TENNESSEE VALLEY AUTHORITY

JUSTIFICATION OF THE SEISMIC DESIGN CRITERIA USED FOR THE SEQUOYAH, WATTS BAR, AND BELLEFONTE NUCLEAR POWER PLANTS

PHASE II

RESPONSES TO NRC QUESTIONS 1 THROUGH 6

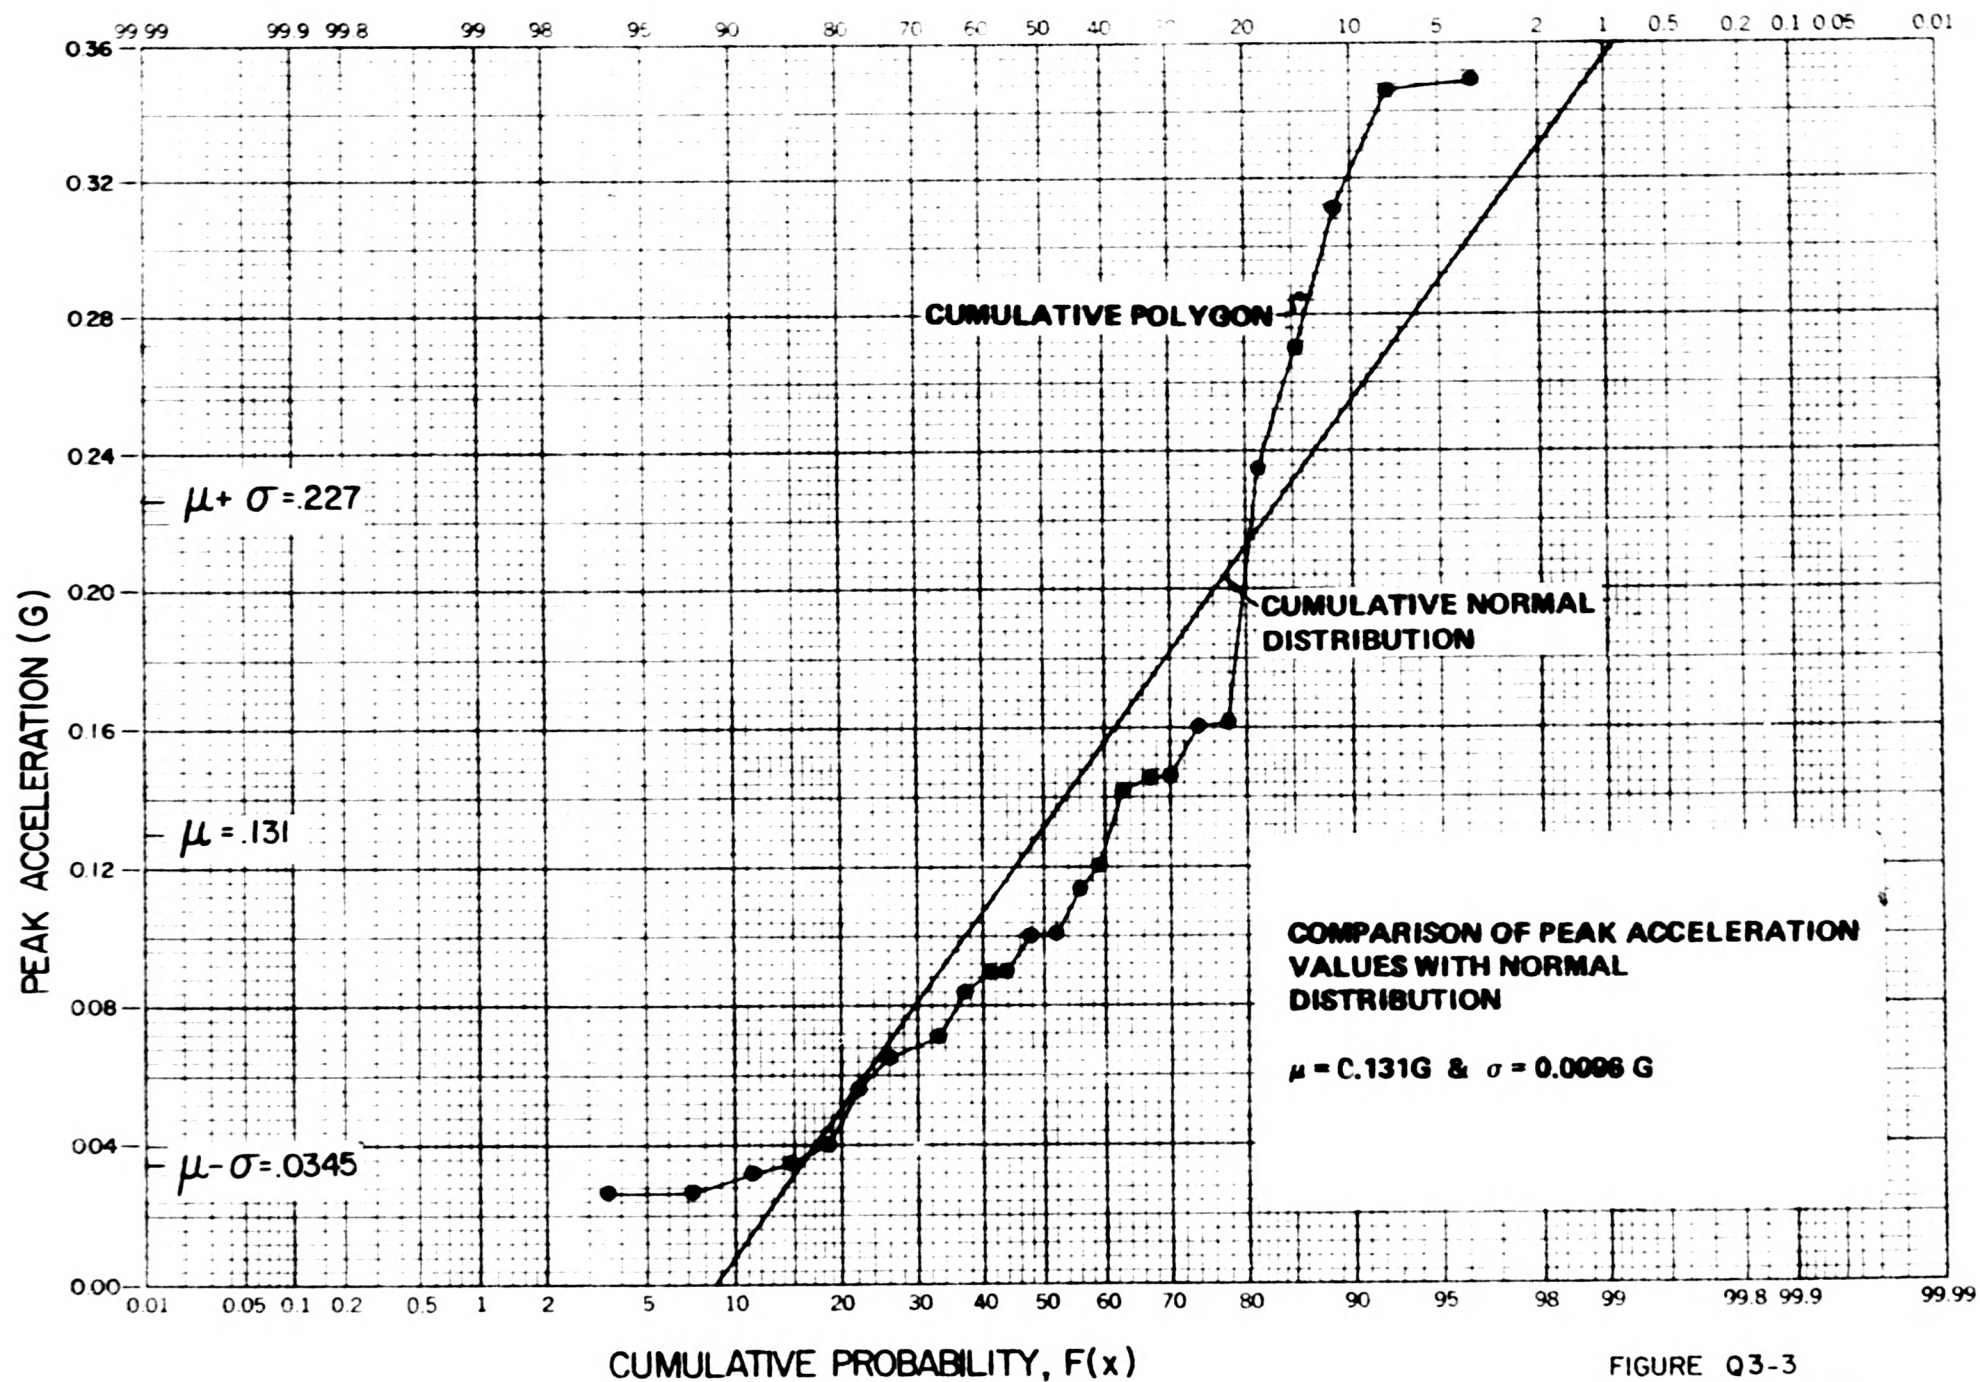
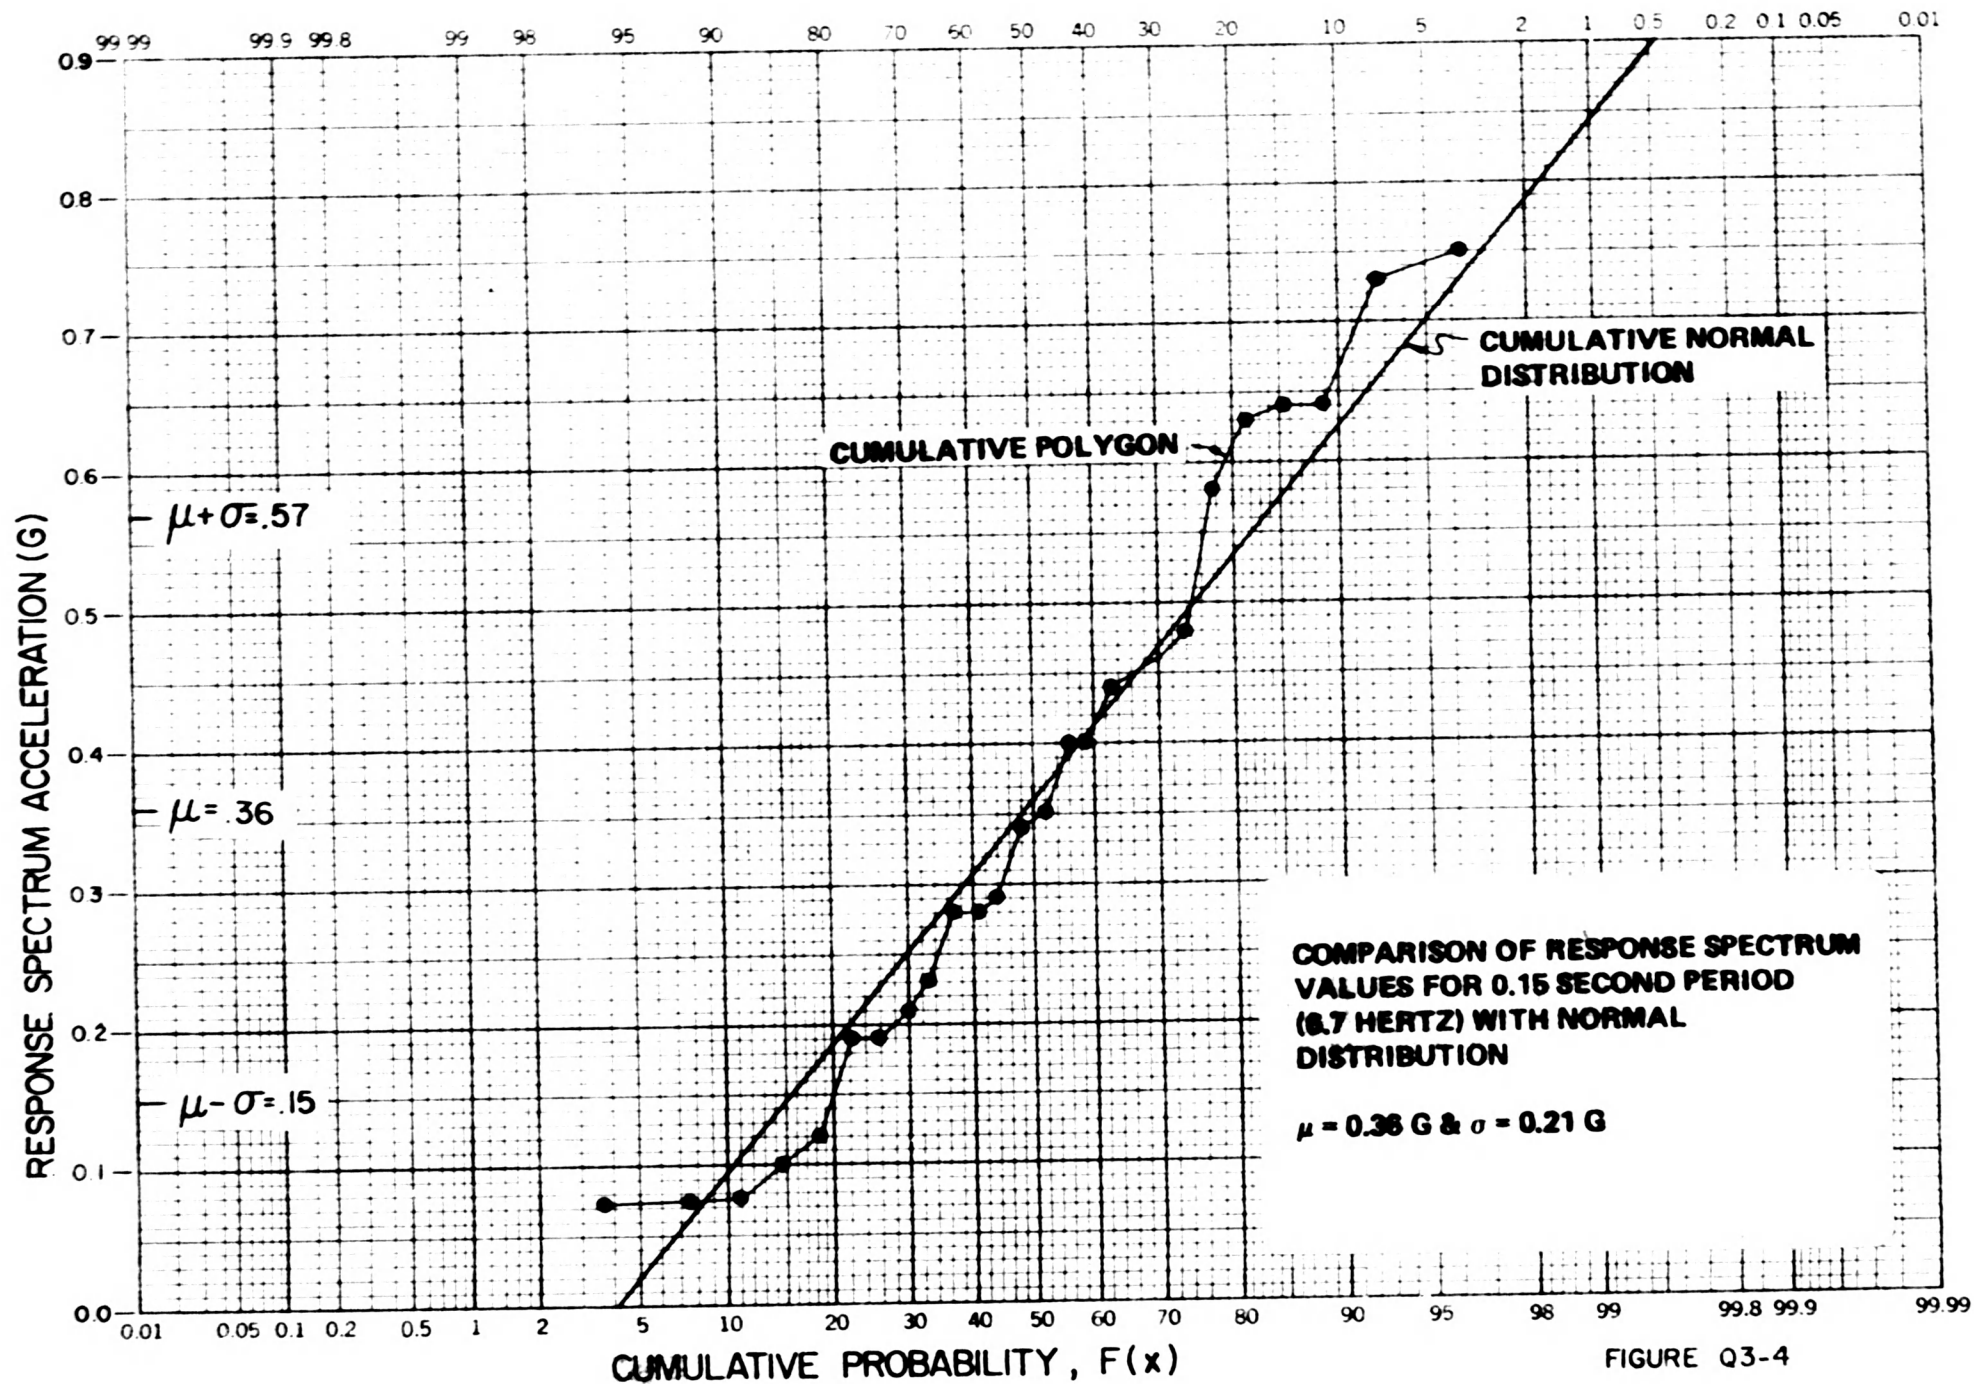
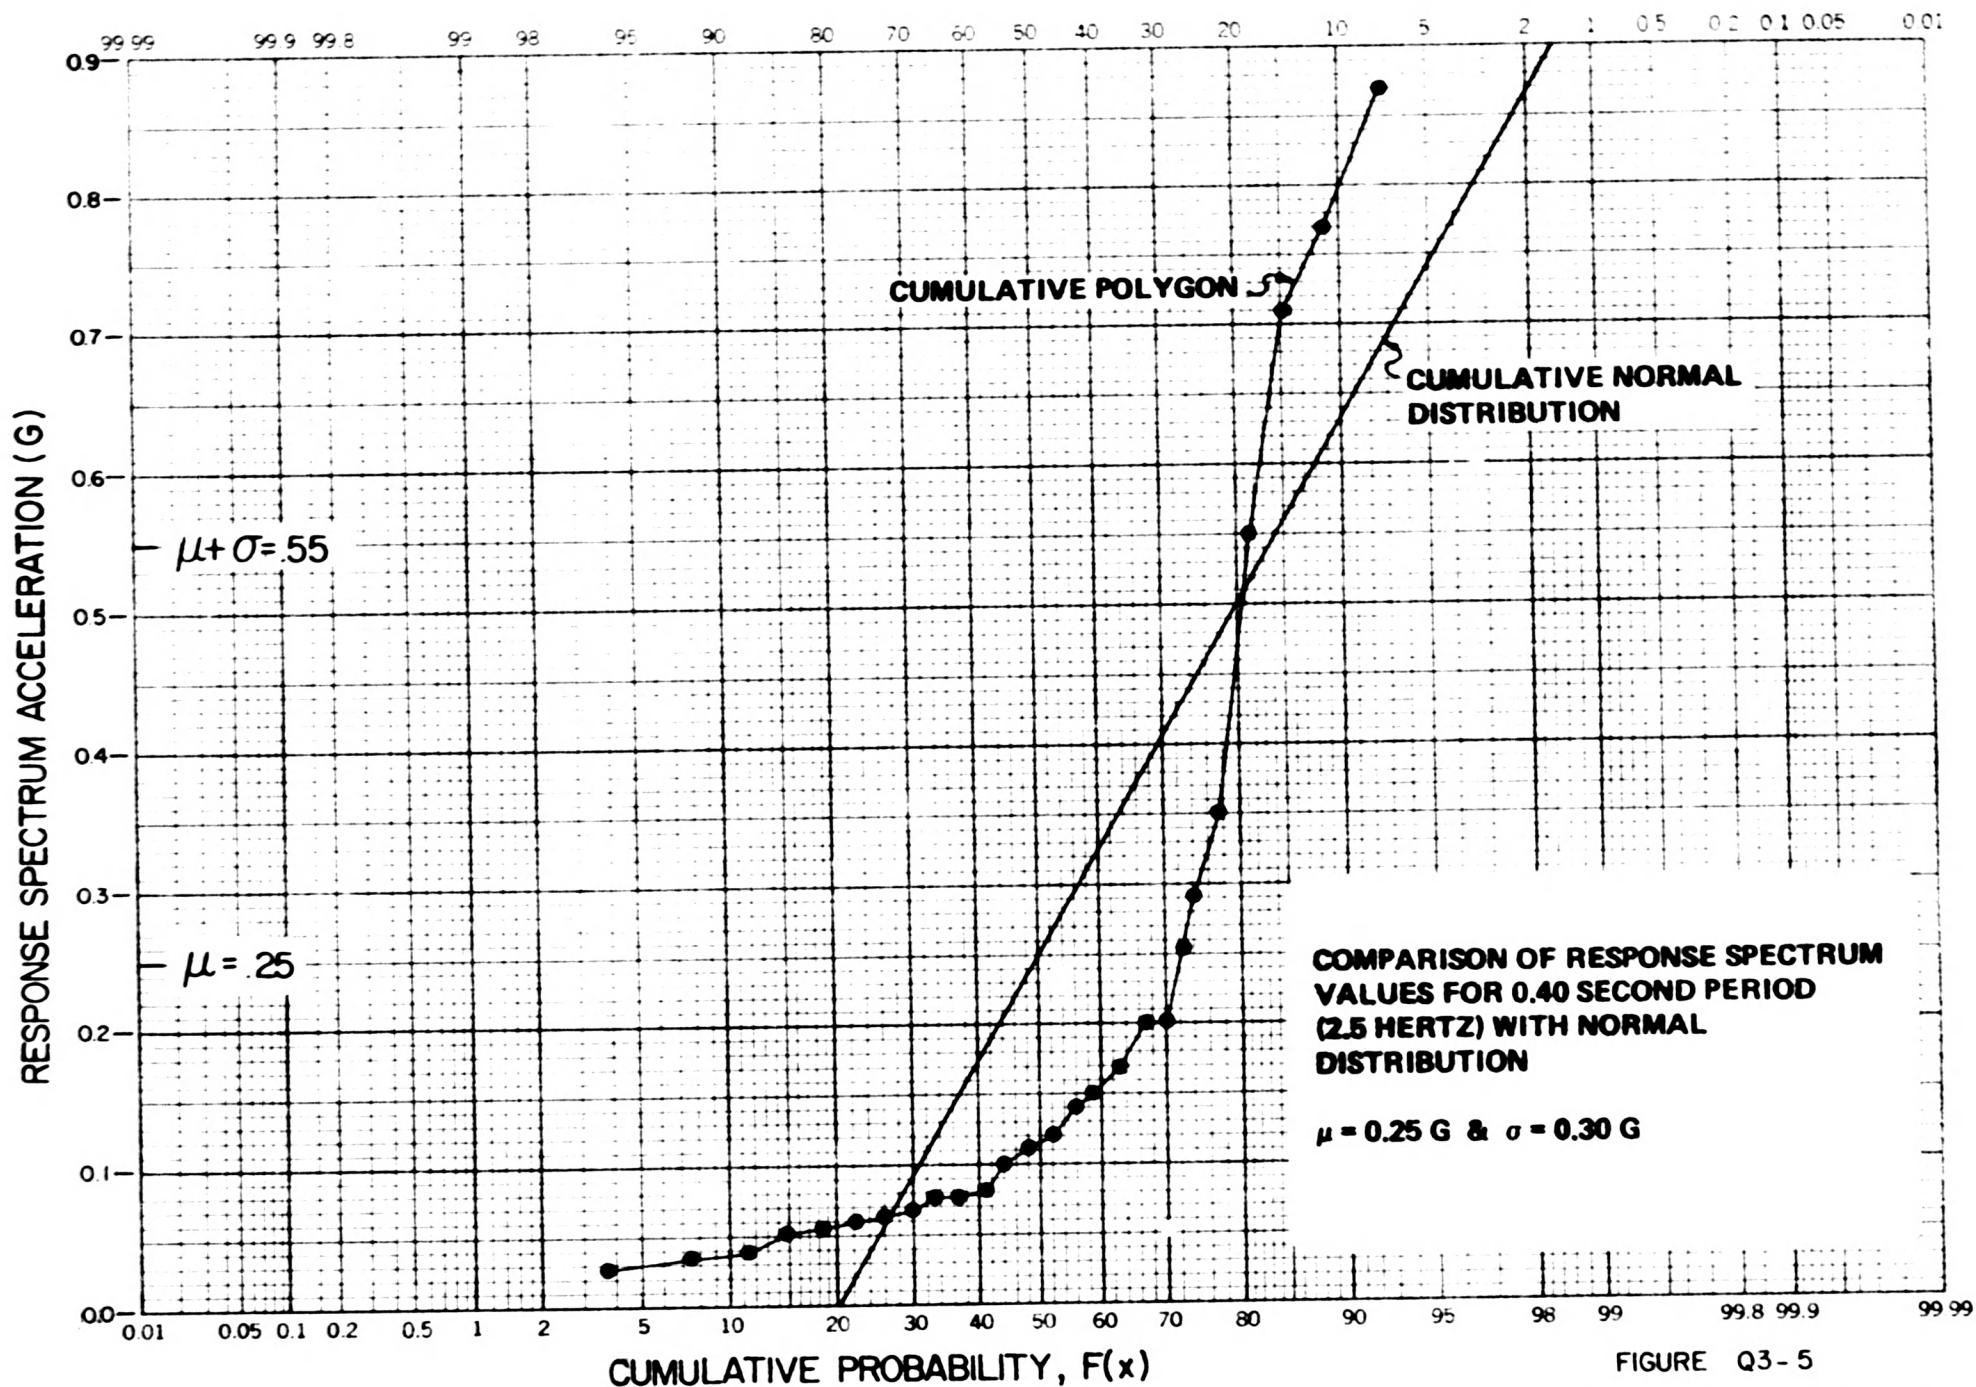
3. Determine whether the distribution of response spectral values at each frequency for the available data is better fit by a normal or lognormal distribution. Calculate 50th and 84th percentile spectra for the appropriate distribution.
4. Determine to what percentile different frequency bands of the design spectra correspond to with respect to the distribution calculated in 3. Discuss the significance of each such frequency band to the engineering analysis of structural components.

Figures Q3-3 through Q3-10 compare the actual data to each assumed distribution. For this comparison only the response spectra for 4 percent damping are used. Figures Q3-3 to Q3-6 compare the actual data to an assumed normal distribution for peak acceleration values and spectral values at periods of 0.15, 0.40, and 4.0 seconds, respectively. Figures
